# **CONNECTION ASSESSMENT & APPROVAL PROCESS**

## ***PRELIMINARY ASSESSMENT REPORT***

*For the Proposed 850MW Development by Calpine Canada Power Holdings Ltd.  
near the Nova Corunna Complex in the Township of St. Clair*

*CAA ID No. 2000-018*

DIAGRAM 2

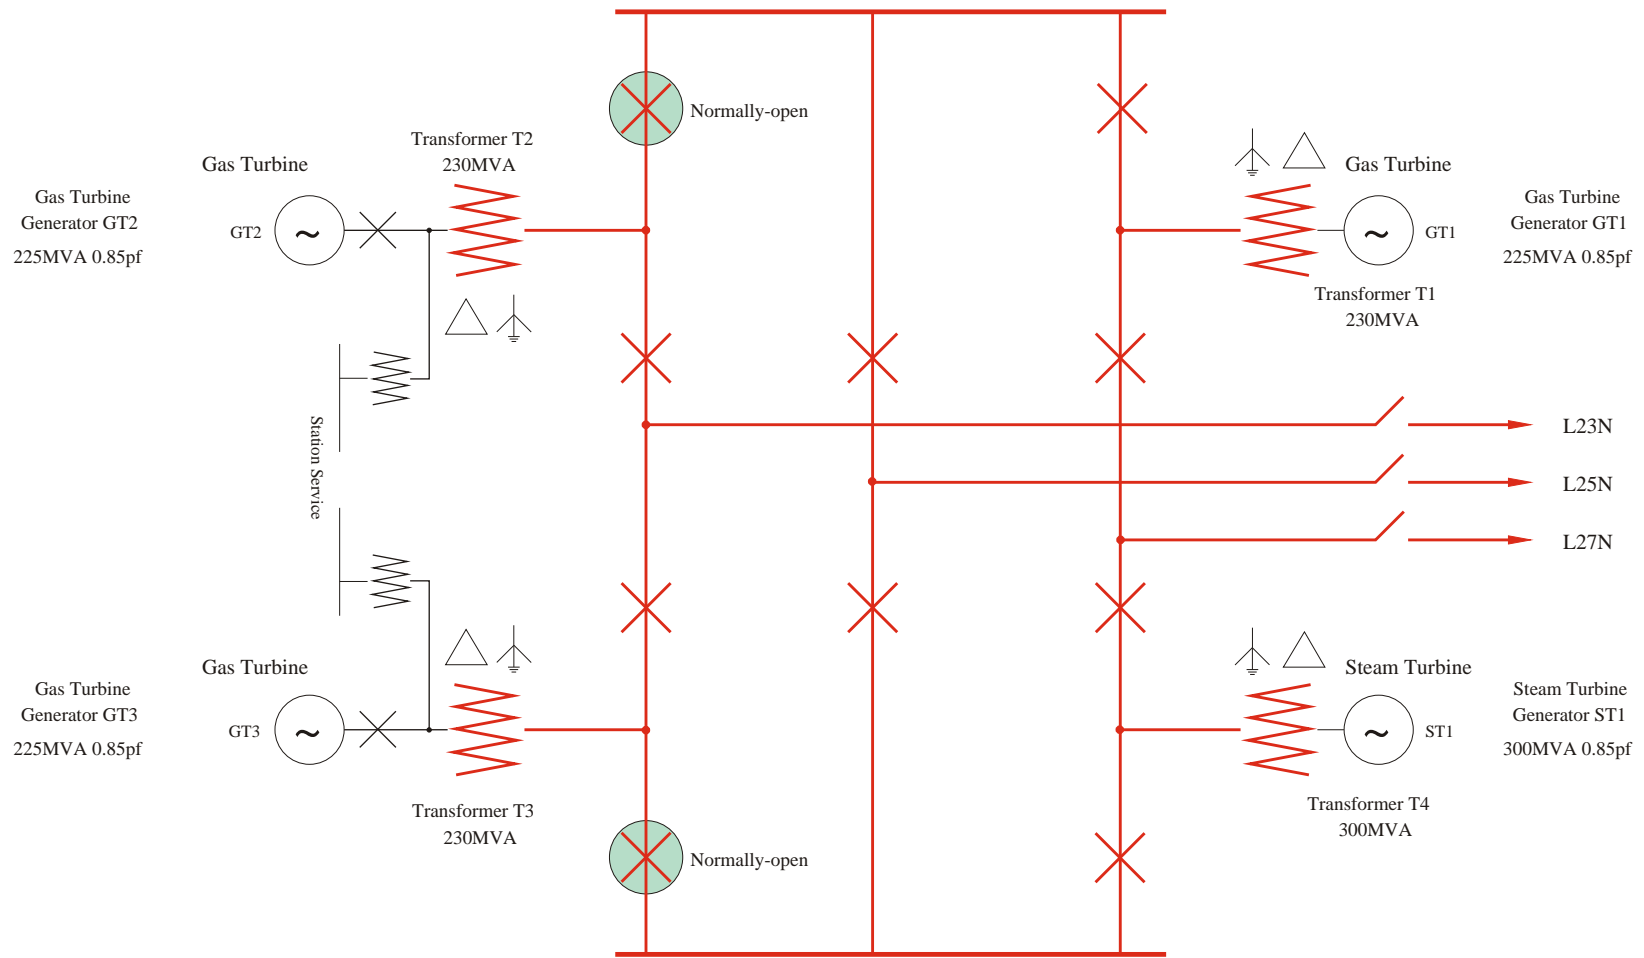
The incorporation arrangement proposed by Calpine Canada takes account of the intended ‘split’ of the Lambton busbar by operating with the 230kV busbar at its new generation facility site similarly ‘split’. Diagrams 1 and 2 show the proposed arrangement.

The proposed busbar arrangement for the Calpine-Corunna Project, as shown in Diagram 2, incorporates the flexibility required to allow different generating units to be associated with different circuits by changing the location of the normally-open points. This flexibility could also be used to allow more of the generating units at the Calpine-Corunna facility to be operated under outage conditions involving one of the Lambton TGS to Scott TS circuits, if the thermal ratings/loadings on the remaining circuits are not restrictive.

The connection arrangement proposed by Calpine Canada for the incorporation of their new Project employs a ‘breaker-and-a-third’ switching station that will limit the possible impact on the local system of any contingencies within the new generating facility. Furthermore, since two of the three tapped connections that are required for the incorporation of the new generating facility already exist (the connections from circuits L25N & L27N to the Nova Corunna Complex) the only increase in exposure will be from the new 1.5km tapped connection on to circuit L23N. This increase in exposure is expected to have minimal impact on the reliability of supply of those loads (Nova St. Clair & Shell Canada) that are supplied from circuit L23N, particularly since they involve DESN connections with an alternative supply from circuit L27N.

The station service supply for the Calpine-Corunna Project is to be obtained from the LV terminals of two of the generator step-up transformers. Consequently the two units associated with these particular generator step-up transformers are to be equipped with LV synchronising breakers, as shown in Diagram 2. Synchronising of the two remaining generating units is to be performed via the 230kV circuit breakers at the new switching station. Because of the various synchronising arrangements that can be employed, it is recommended that all of the circuit breakers that are to be installed at the switching station should be capable of withstanding a 2 pu voltage across their open terminals.

DIAGRAM 4

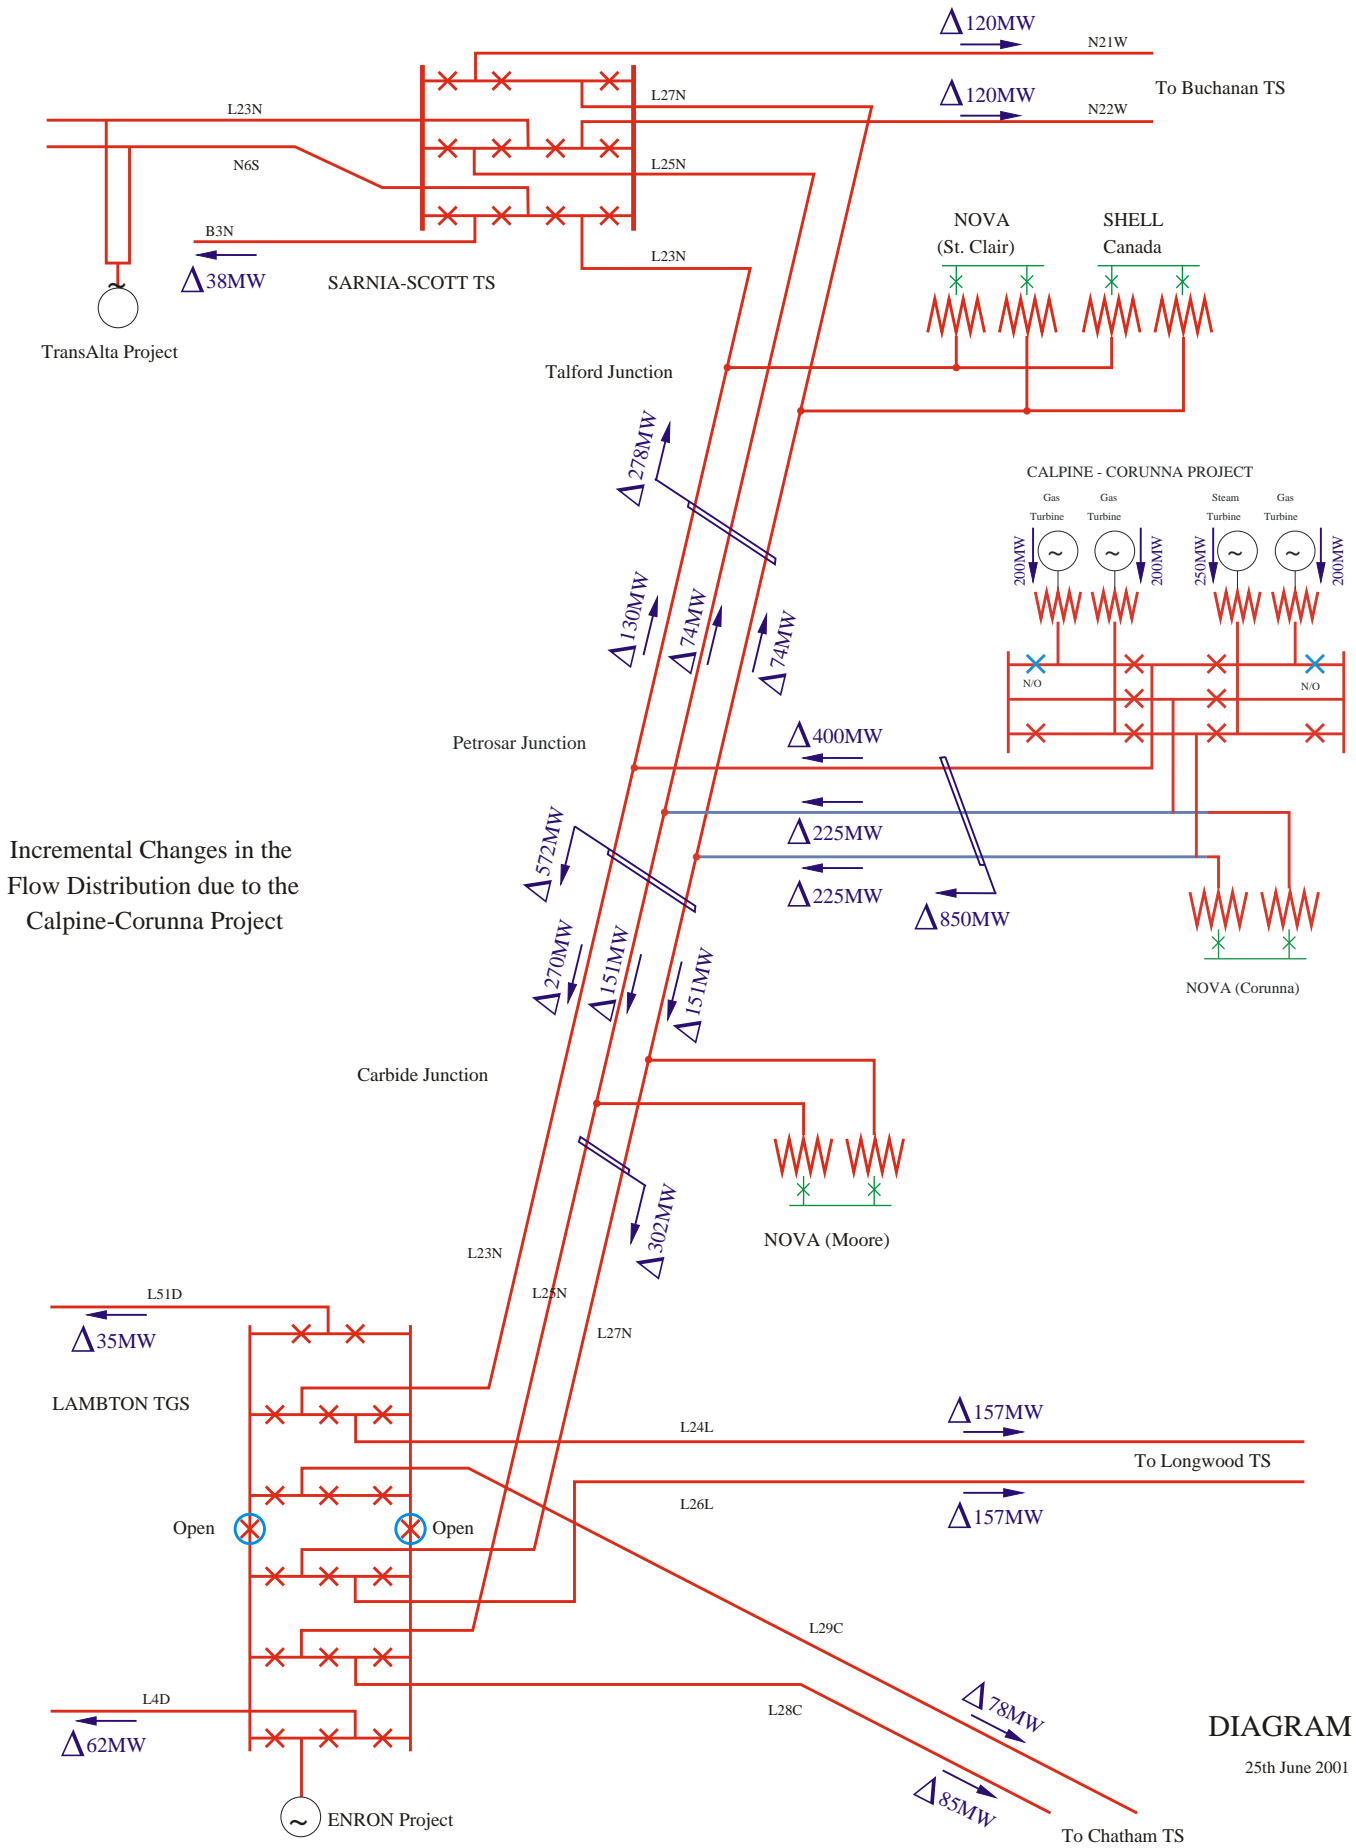
Diagram 4 shows the incremental impact on the flow distribution within the local area of the Calpine-Corunna Project.

This shows that approximately  $\frac{2}{3}$  of the output from the Calpine Project will flow towards Lambton TGS with only  $\frac{1}{3}$  flowing toward Sarnia-Scott TS. Since, under Import Conditions, the normal flow direction on circuits L23N, L25N & L27N is from Lambton TGS to Sarnia-Scott TS, the Calpine Project would therefore have the effect of reducing the flows on the section of circuits L23N, L25N & L27N between Lambton TGS & Petrosar Junction, while increasing them between Petrosar Junction and Scott TS. This will result in the flows on the sections north of Petrosar Junction becoming the more critical.

Revised Proposal for Reconfiguring  
the 230kV busbar at Lambton TGS  
to allow it to be operated 'split'

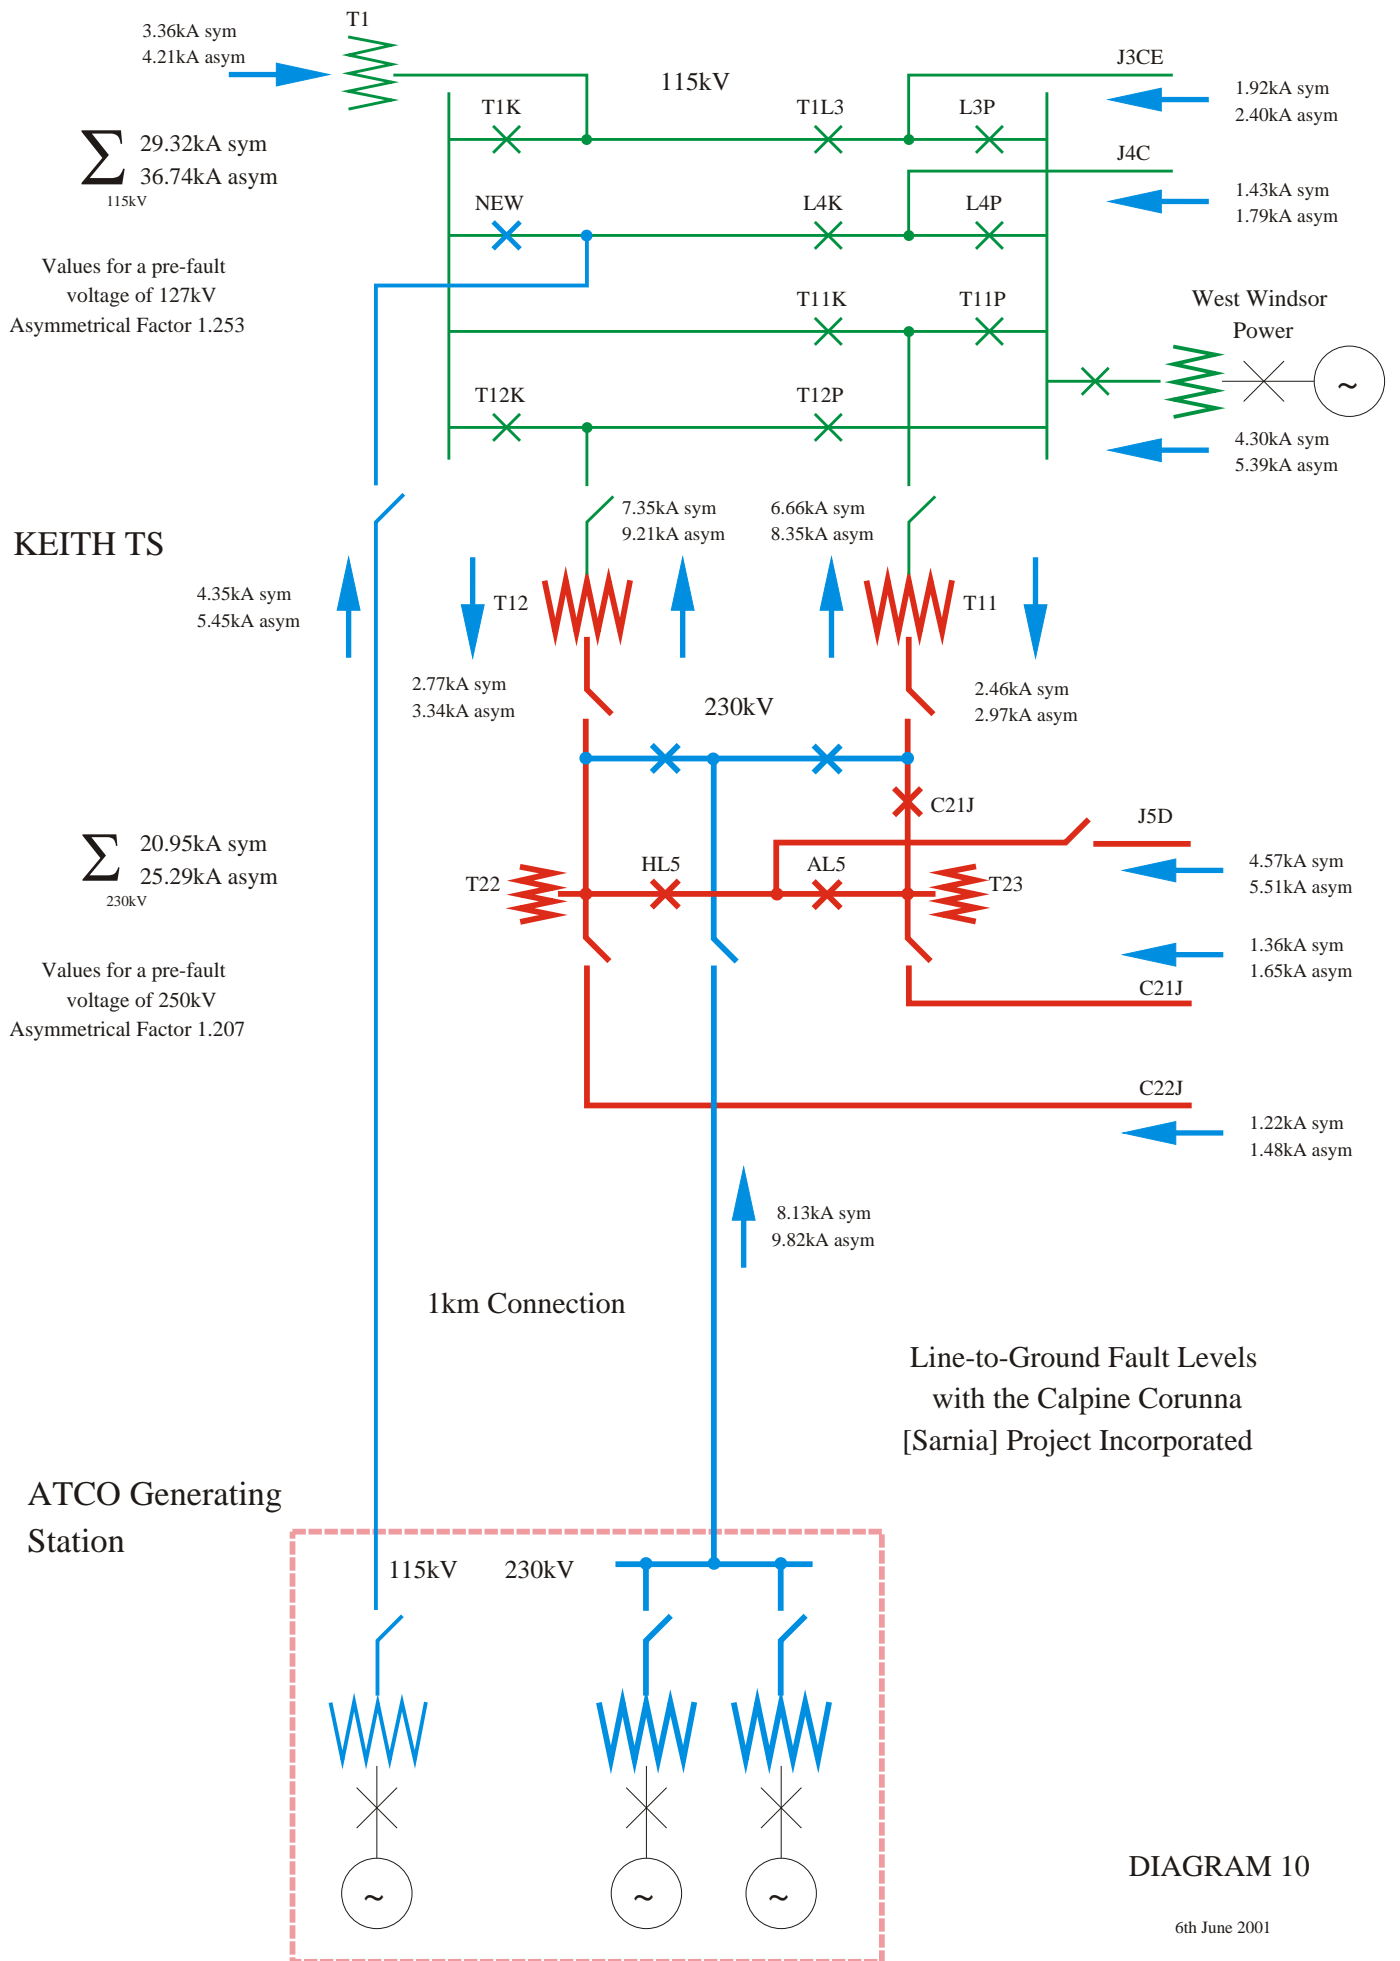
The results are summarised in the Tables below. It should also be noted that as a result of these studies a revised arrangement for the reconfiguration of the northern half of the Lambton busbar was considered, and this was found to result in an improved transfer capability under Import Conditions. This revised arrangement is shown in Diagram 12.

The response of the revised termination arrangement for the 230kV circuits at Lambton TGS, as shown in Diagram 12, was examined to determine whether the simultaneous loss of circuits L23N and L29C, for a breaker failure condition on circuit breaker L23L26, would be as limiting as the simultaneous loss of circuits L23N and L24L.

*It is therefore proposed to adopt this revised termination arrangement as the preferred option for reconfiguring the 230kV circuits at Lambton TGS and all future analysis will be based on this arrangement.*
